**Re: Summary Report for 8-Acre Cap and Site Problem Areas
National Zinc Company Site, Montgomery County, Kansas
KDHE Project #C3-063-00026
Consent Order: 03-E-0022**

RE: Site Problem Areas
National Zinc Company Site, Montgomery County, Kansas
KDHE Project #C3-063-00026 Consent Order Case #03-E-0022

**RE: Limited Site Inspection on March 29, 2011
National Zinc Company Site, Cherryvale, Kansas
KDHE Project #C3-063-00026 Consent Order Case #03-E-0022**

Photo 4

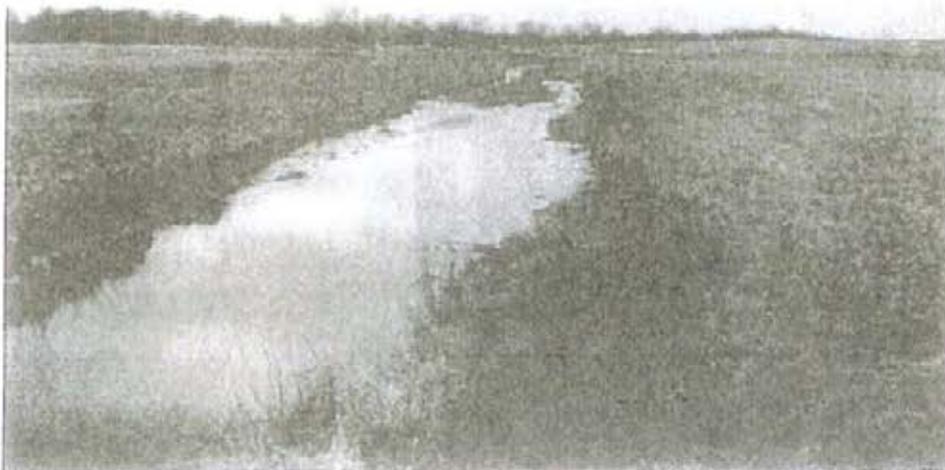
- 4) Alleviate ponding in southern drainage channel, – Ponding is routinely noted in the southern drainage channel southeast of the ODA even though Site drainages are cleared of obstructions. Refer to *Figure 1* and *Photo 4* KDHE/BER requests the storm water drainage channel grading design be reevaluated and appropriate corrective measures be implemented to ensure the drainage channel functions properly

Comments Area of ponding along southern storm water drainage channel

Response: The drainage on the southern part of the Site, including the southern drainage channel southeast of the ODA, is a natural drainage feature which has a very slight grade. This area had been identified as a marshy area prior to remediation. Creeks and channels naturally develop pools which reflects conditions in the channel bottom. We believe this is a natural condition and that the southern drainage channel functions effectively as designed to convey water from the Site as well as from areas upstream and off the Site, even though drainage may be slow at times or pools may develop. It should be remembered that pooling may not be a detriment, since it can act to slow down water velocity of drainage and the erosion or water cutting that increased velocity may cause.

Respondents will inspect this area further when the 8-Acre project work is being performed. This could include additional confirmatory surveying as appropriate, since there will be a surveyor on Site during the 8-Acre project.

Photo 1

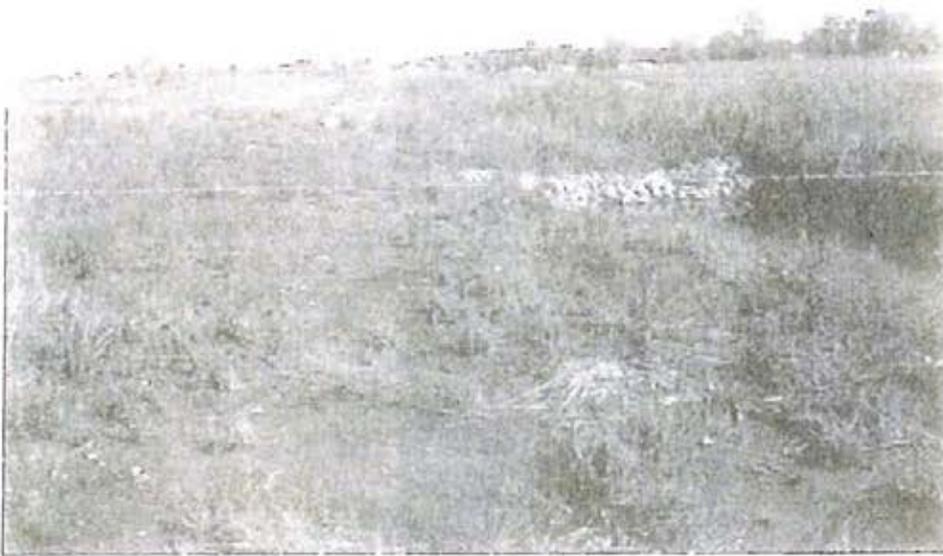
water crossing and the southwest bank of the On-Site Disposal Area (ODA) Multiple reseeded efforts have been unsuccessful in establishing an adequate stand of vegetation. Refer to *Figure 1* and *Photo 1* Therefore, KDHE/BER requests that rip rap be placed along the southern drainage's northern slope (Refer to *Figure 1*) to reduce washouts and scouring of vegetation.

Comments. Sparse vegetation and erosion along southern drainage where slope is not riprapped.

Response: The Respondents inspected the area south of the OnSite Disposal Area (ODA), east of the low water crossing along the south drainage. Areas of poor vegetation and minor erosion rills were noted where sheet flow and channeling of water from the ODA flows across the area. The Respondents previously have seeded and repaired this area. Hay bales set up as erosion breaks to prevent a reoccurrence have not been maintained as part of the ongoing O&M, which has contributed to the inadequate vegetation and rill formation.

When Respondents are on Site for implementing the 8 Acre project, they will armor the area in question with rip rap, and confer with the City as to whether installation of any additional water breaks or other Interim O&M measures would be effective.

Photo 2

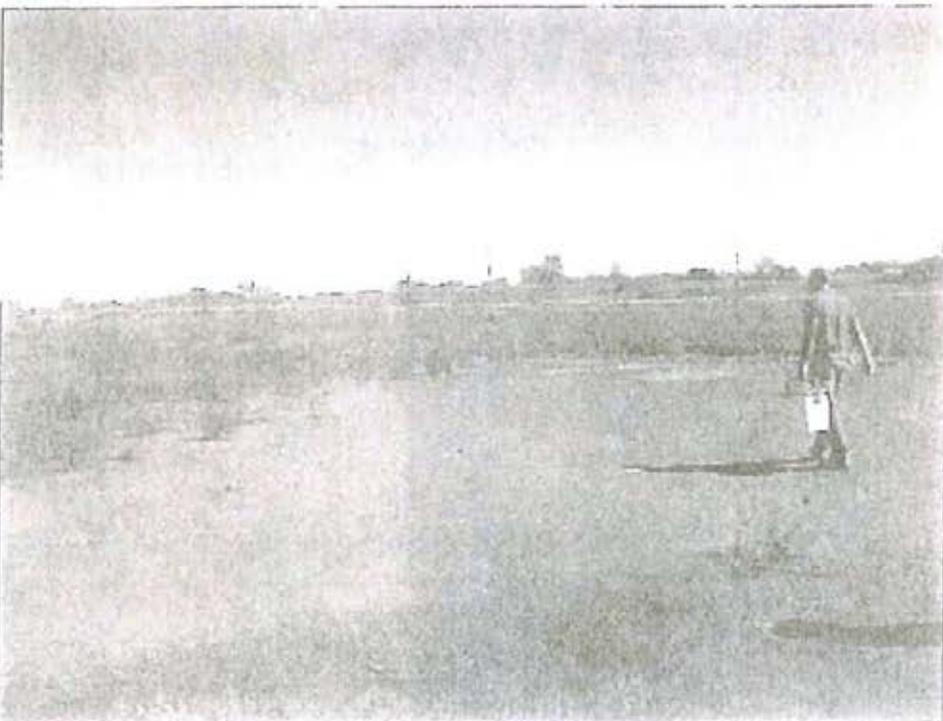
- 2) Revegetate bare spots within 8-Acre Cap Area, – Spots barren of vegetation are routinely noted within the 8-Acre Cap Area. Several attempts at reseeding these areas have been to no avail Refer to *Figure 1* and *Photo 2* As noted in post-Removal Action documents, the existing cover and vegetation on the 8-Acre Cap Area were left intact and not supplemented. However, this area is a capped structure that must have an effective vegetative cover as required of other capped areas at the Site. Therefore, KDHE/BER requests that necessary supplements or additional top soil be provided to augment reseeding efforts.

Comments. Spot barren of vegetation routinely noted after multiple reseeding efforts.

Response: The Respondents recognize there are areas within the 8-Acre Cap Area where seed has not taken hold, and note the area of concern identified in KDHE's October 26 letter. Respondents will address revegetation within this area as part of the upcoming 8 Acre project work.
